Clamping pins

Produktänderung
Product modification
Modification des produits

D 3002A 09.2020

SN1534-

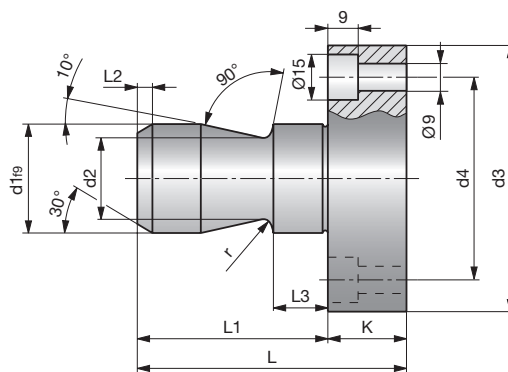
* Auslaufend! Abverkauf bis 31.12.2020.
Discontinued! Sales until 31.12.2020.
Discontinué ! Ventes jusqu'au 31.12.2020.
